Sent: 16/11/2021 10:45:22 PM
Subject: DA/2021/1812 - 4 Munoorra Street, Seaforth - Submission
Attachments: Submission - 4 Munoorra Street, Seaforth.pdf;

**Submission in regards to DA/2021/1812 Development Application (“the DA”)
4 Munoorra Street, Seaforth**

“Construction of a dwelling house.”

Figure 3 – Principal private open space of 50 Grandview Grove (Corona Projects, 2021)

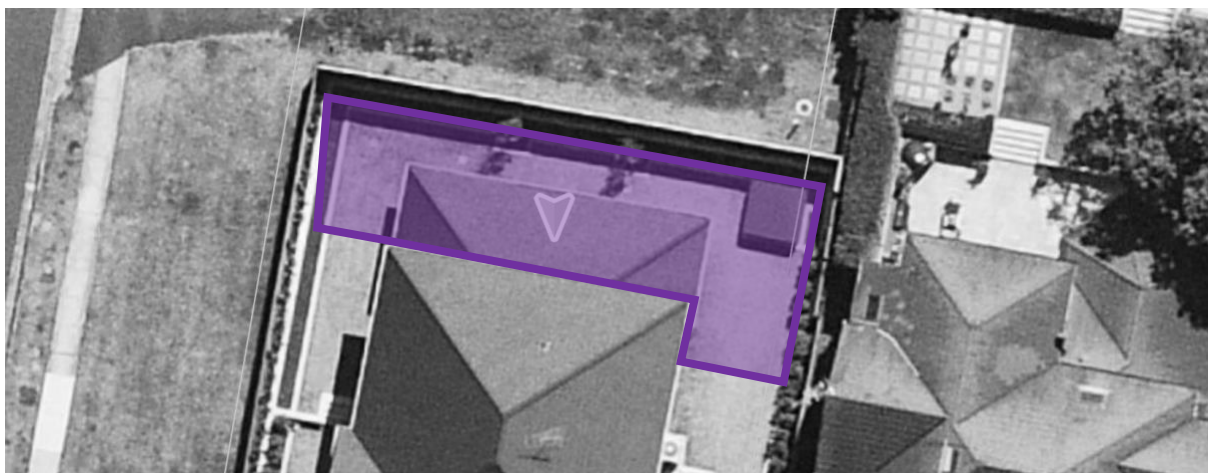
At present the principal private open space of 50 Grandview Grove receives sunlight on the Winter Solstice due to its intentional northerly orientation.

Figure 8 – Estimated loss of solar access due to height and proximity of proposed dwelling

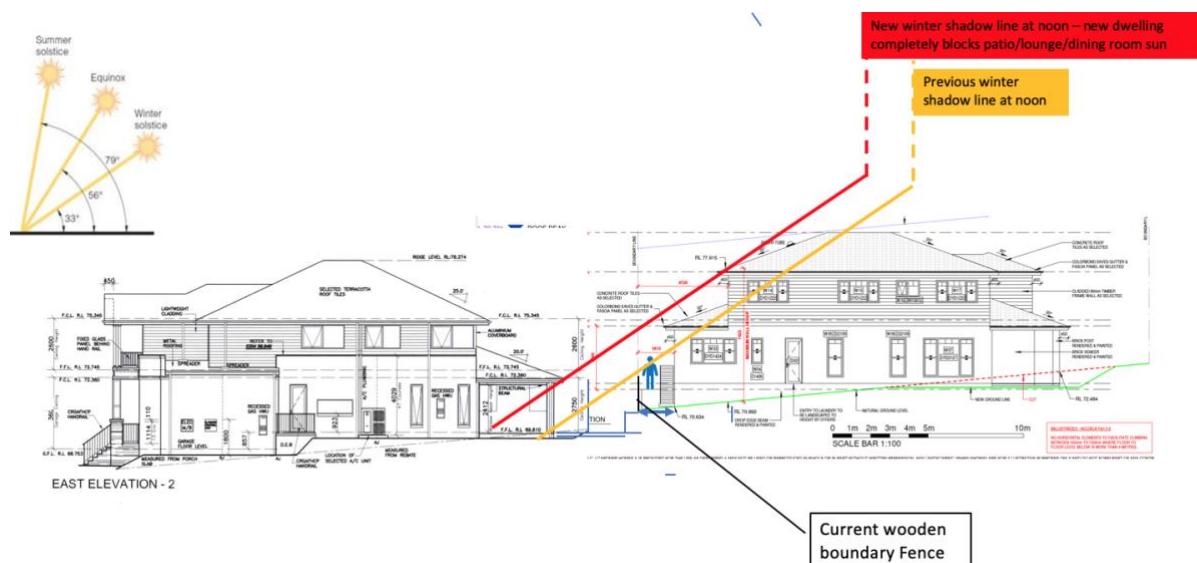
Despite the above, with the limited modelling available it can still be determined that the works proposed under DA/2021/1812 will substantially decrease the amount of sunlight received by the rear garden and patio of 50 Grandview Grove during Winter months beyond a reasonable degree. This will result in a non-compliance with the applicable solar access objectives and controls under Part 3.4.1 of the Manly Development Control Plan (MDCP) 2013 which requires development to:

The above example is identical to the circumstances imposed by DA/2021/1812 on the rear garden and patio of 50 Grandview Grove. The proposal is expected to block most significant sunlight during most hours of the day in June.

Figure 11 – Fill area of concern (southern elevation)

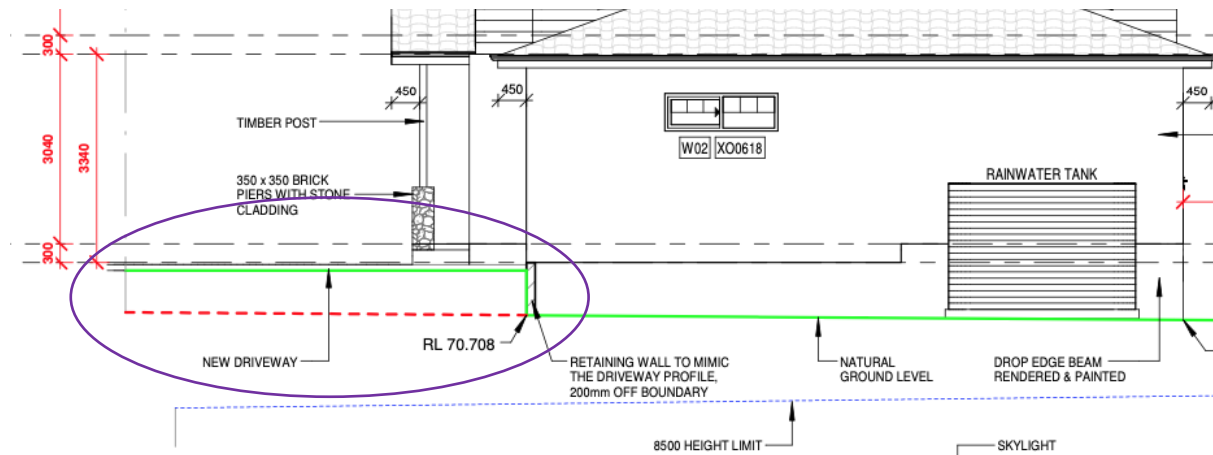
Whilst the lack of proposed south-facing windows is appreciated by the owners of 50 Grandview Grove, the raised nature of a portion of the southerly setback proposed under DA/2021/1812 will allow for direct, unobstructed and close views into the principle private open space (rear garden, patio and spa), and primary habitable living areas (living, dining and kitchen spaces) of 50 Grandview Grove. Figures 9 and 12 show the expected views from the proposed raised setback created by way of proposed earth fill, straight into every shared living space of the single dwelling at 50 Grandview Grove, resulting in a substantial and unacceptable visual privacy breach.

The proposed overlooking is in conflict with the Part 3.4.2 of the MDCP 2013 which states that development must “*minimise loss of privacy to adjacent and nearby development by appropriate design for privacy (both acoustical and visual) including screening between closely spaced buildings*”

- a) **Action:** Retain the existing ground level for the proposed driveway and southern external setback. Instead, step the design.
Outcome: This will protect the privacy of 50 Grandview Grove and reduce overshadowing.

Figure 13 – Recommendations – southern elevation (Corona Projects, 2021)

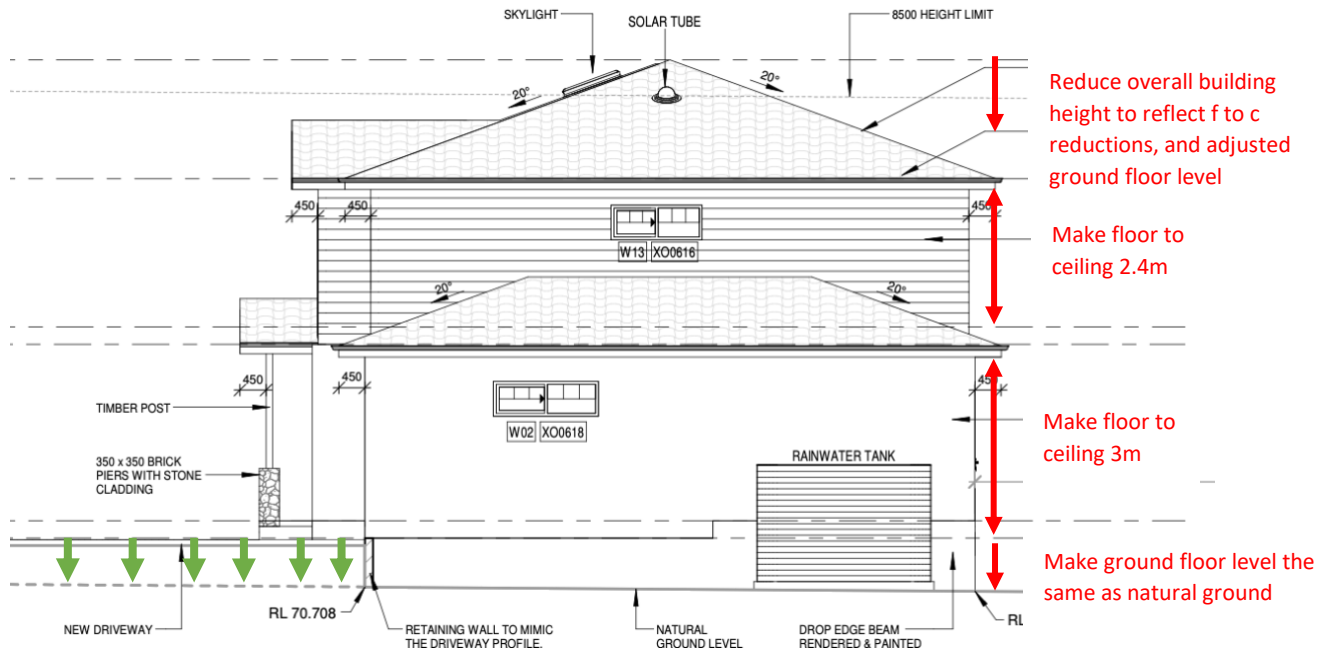
A more skilful design by way of scheme reconfiguration can allow both 50 Grandview Grove and 4 Munoorra Street to retain and/or improve their amenity. Actions a – d provide a suitable scheme which solves all concerns raised within this letter and allow for a new dwelling house at 4 Munoorra Street, Seaforth.

- b) **Action:** Reduce the building height by reducing the floor to ceiling height of the ground floor to 3m, and the floor to ceiling height of the first floor to 2.4m.
Outcome: This will reduce overshadowing and visual bulk for 50 Grandview Grove.

- c) **Action:** Increase the upper floor southern setback to 11 metres.
Outcome: This will reduce visual bulk and overshadowing for 50 Grandview Grove as the shadows from the new upper floor will primarily fall on the roof of the proposed ground floor below rather than the rear garden and patio of 50 Grandview Grove.

- d) **Action:** Increase the ground floor southern setback to 3 metres.
Outcome: This will reduce the extent of shadow cast on the rear garden and patio of 50 Grandview Grove, and achieve numerical compliance with the side setback MDCP 2013 control.
